From: Ann Marie Donlon
Sent: 08 March 2010 16:09
To: Sonja Smith
Subject: FW: Regulation 18 - outstanding information
Attachments: Y7334-PR-002 bound_RevisionB.pdf

From: Madeleine Healy [mailto:Madeleine.Healy@CorkCoCo.ie]
Sent: 08 March 2010 09:12
To: Ann Marie Donlon
Subject: RE: Regulation 18 - outstanding information

Project: **MIDLETON WWTP EPA LICENCE APPLICATION**

Drawing Title: **ATTACHMENT B.1 (REVISED) AGGLOMERATION BOUNDARY SERVED BY WASTE WATER TREATMENT WORKS**

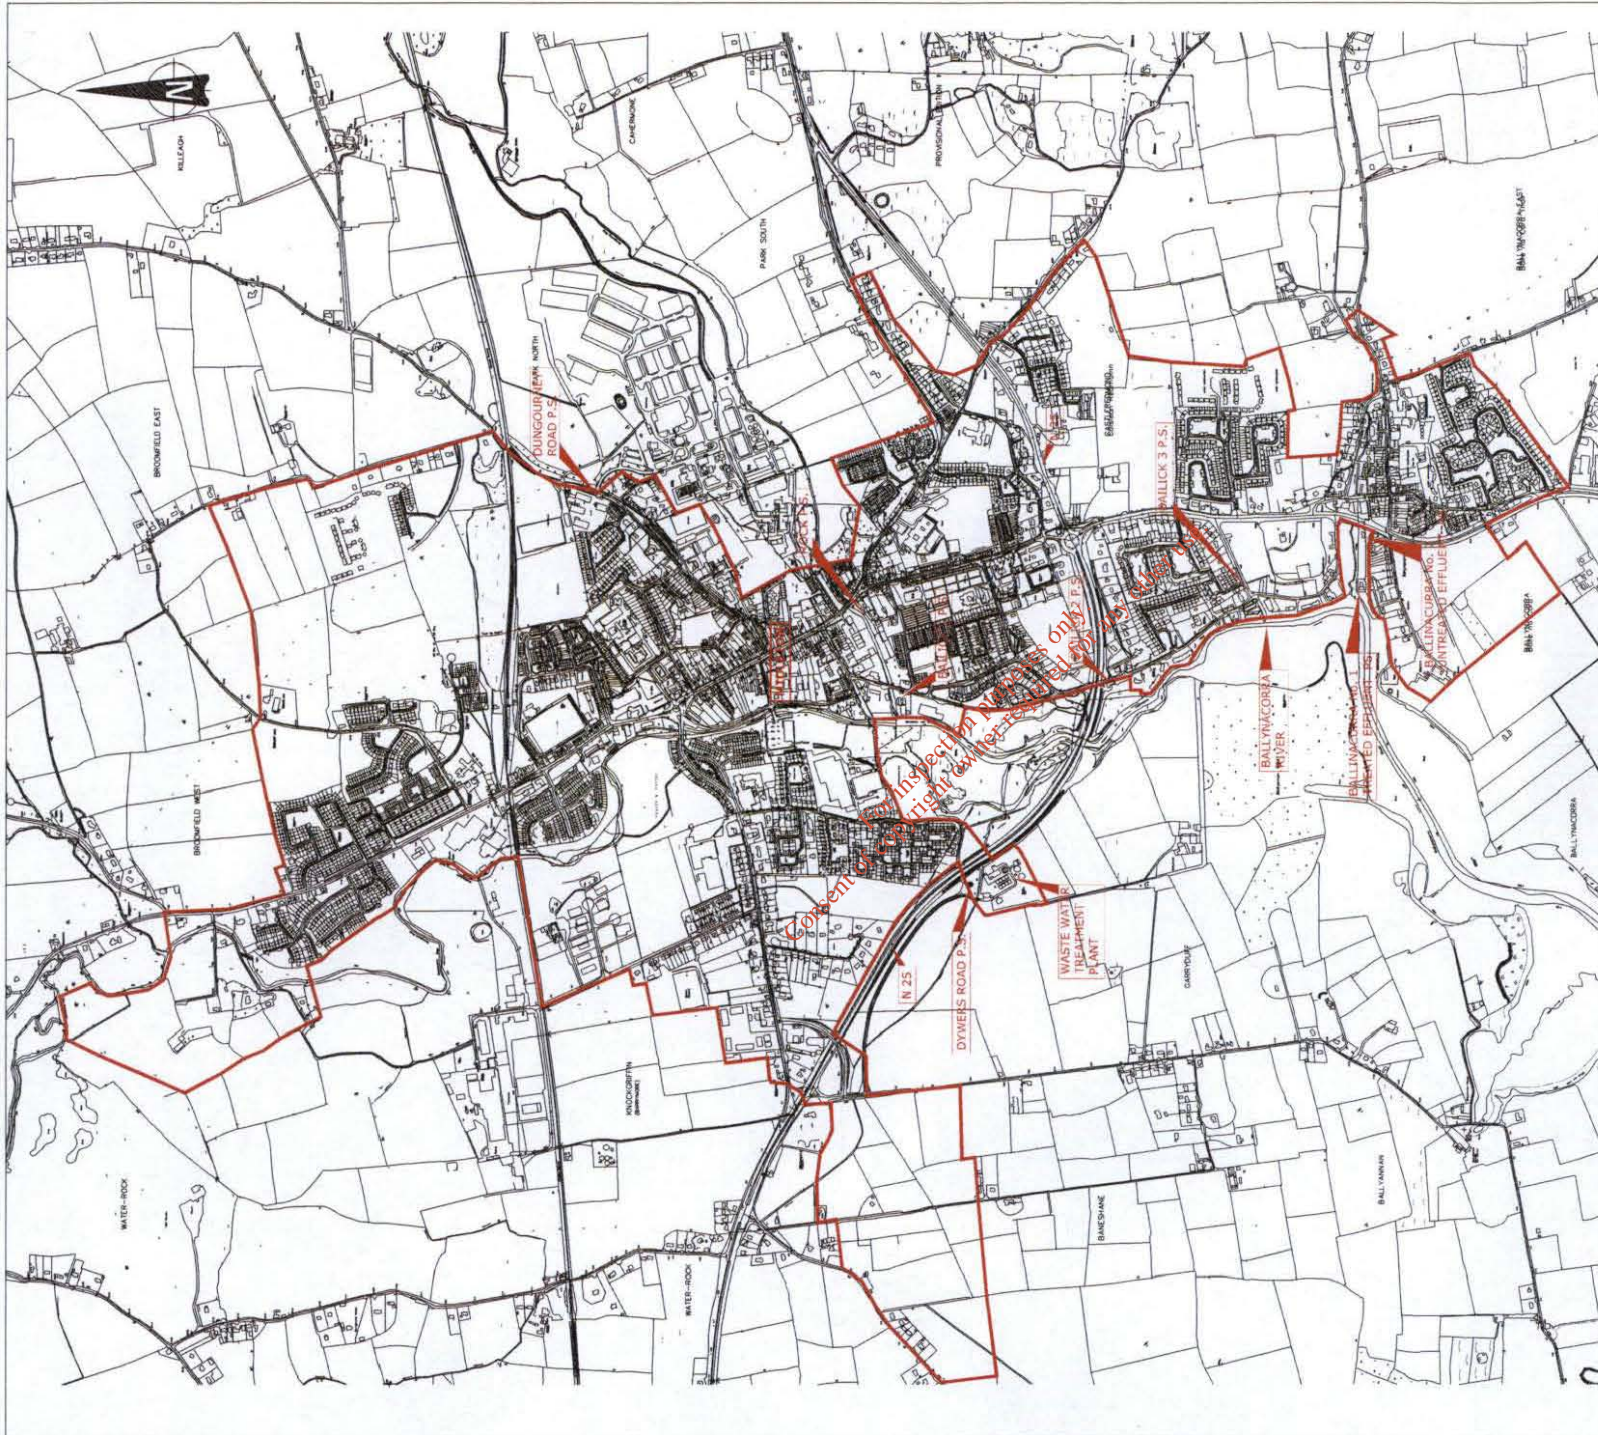
Rev	Description	Drawn	Chkd	Date
B	Agglom. Bndy revised to include W.W.T.P.	MM	MH	04.03.10
A	Under Construction-Removed Dwyers Road	MM	MH	08.09.09
